UNITED STATES PATENT AND TRADEMARK OFFICE

10/817,125

Office Action Summary	Application No. 10/817,125	Applicant(s) MUHANNA ET AL.	
	Examiner JAMES L. SWIGER	Art Unit 3775

DETAILED ACTION

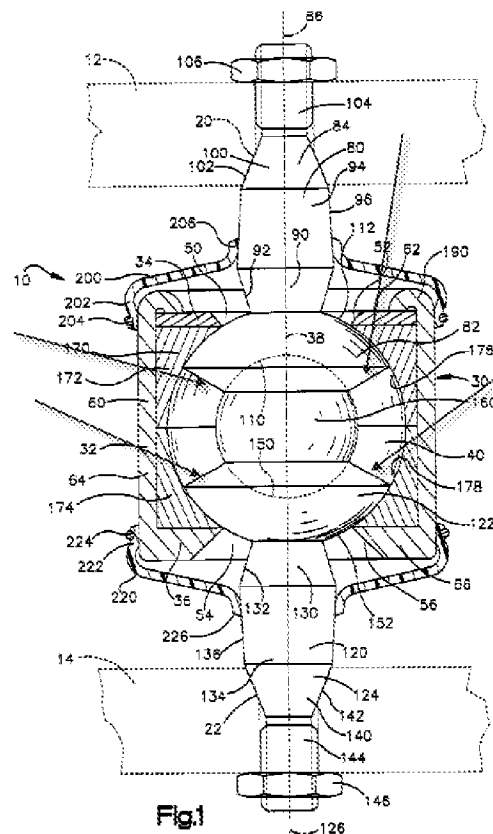
device disclosed by Tatar is also capable of being adjusted in a disassembled state, but in the assembled state (see Fig. 5) the ball collet (130) is seated in the channel (126), which may be considered concave. The rod also goes through the bore of the collet and the cap (140) is screw-coupled to the posts (125a and 125b), which have threads on the inner surfaces (124). These threads are considered integral at least with the insertion portion of the yoke portion. The yoke portion is considered fixed relative to the threaded insertion portion (upper part), which may be considered a functional limitation of the structure. Considering the entire upper portion as a yoke, the individual 'posts' of the yoke are threaded on the inner surfaces and create a concave seat (towards the bottom).

Tatar discloses the claimed invention except for wherein the second end of the rod has a partial hemispherical ball member having a convex inner surface facing an inboard side, and a conical surface facing an inboard side, a centrally located protrusion that is spherical, and wherein the conical surface tapers towards the spherical protrusion. El-Haw et al. disclose ball joint that is designed to allow two elongated members such as rods (for example, 94, 120, Fig. 2), articulate with respect to one another while remaining jointed. El-Haw disclose a partially hemispherical ball member (82) at an end of a rod-like member having a convex inner surface facing an inboard side (Fig. 2, 112), and an outboard side that has a conically tapering portion (see Fig. 1 below) and/towards a centrally located spherical protrusion.
